DEVELOPMENT APPLICATION

APPLICATION NUMBER:	PLN-26-011
PROPOSED DEVELOPMENT:	Partial change of use to Café (Food Services)
LOCATION:	166 Main Road Austins Ferry
APPLICANT:	Pinnacle Drafting & Design
ADVERTISING START DATE:	18/04/2026
ADVERTISING EXPIRY DATE:	02/05/2026

PLN-26-011
166 Main Rd, Austins Ferry

Traffic Impact Statement

Floor Plan - Proposed

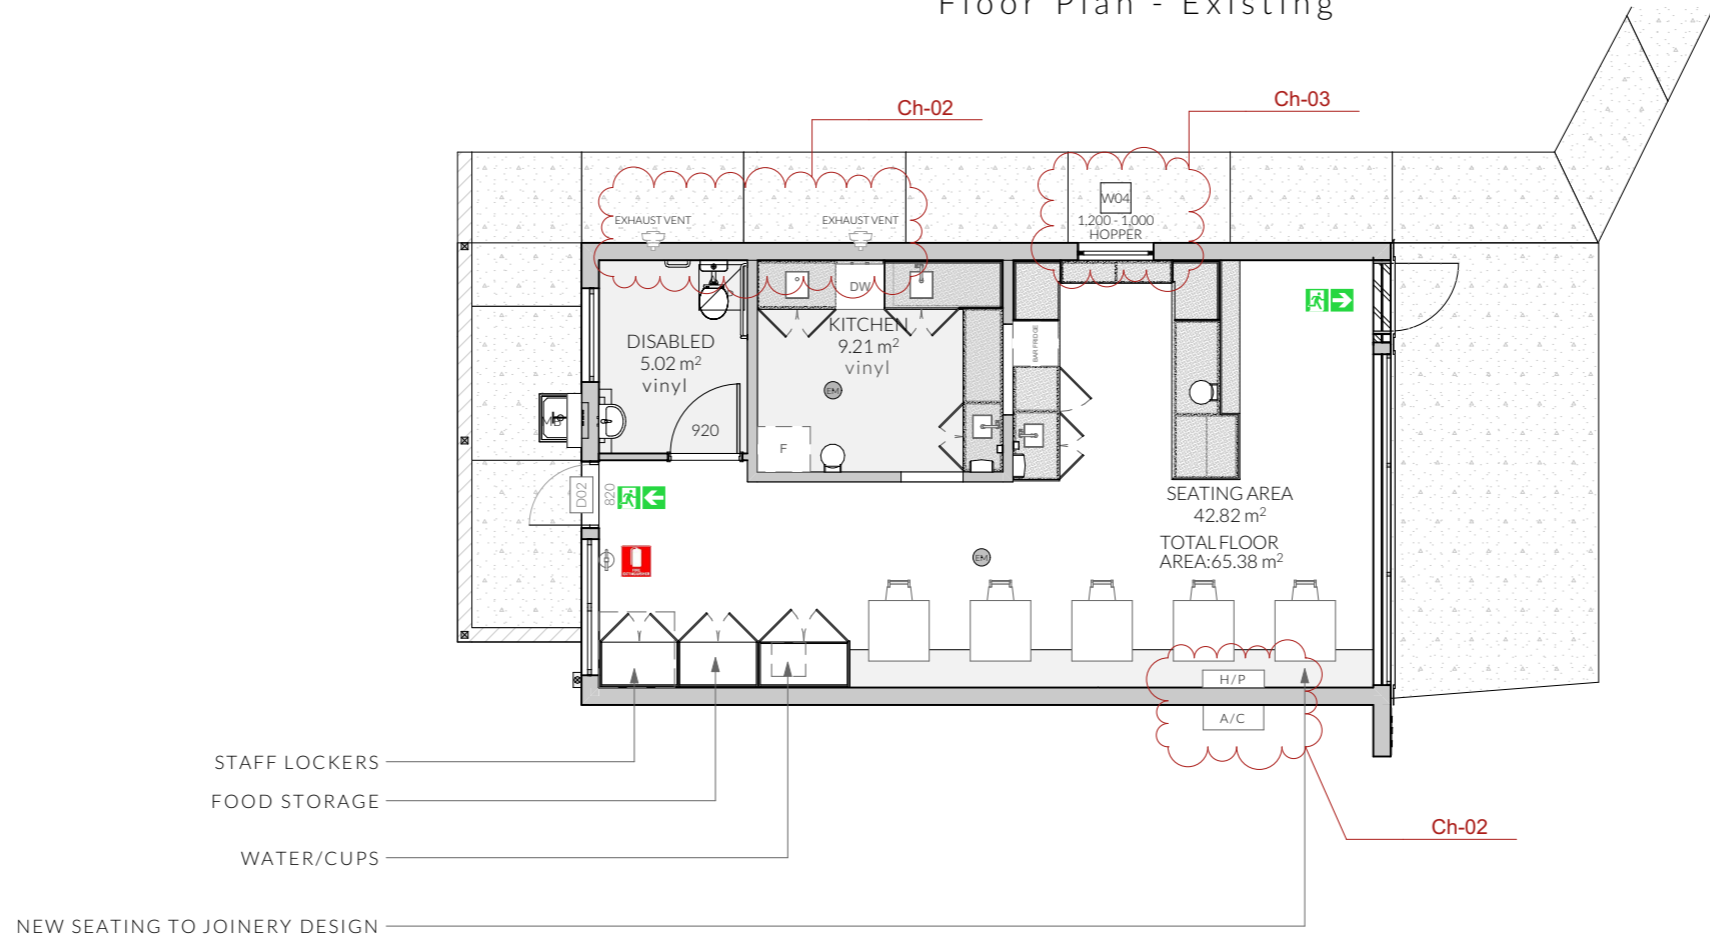
Ch-01

Internal seating: 8
External Seating: 22
Total: 30

6am - 2pm Monday - Friday
6am - 2pm Saturday/Sunday & Public Holidays
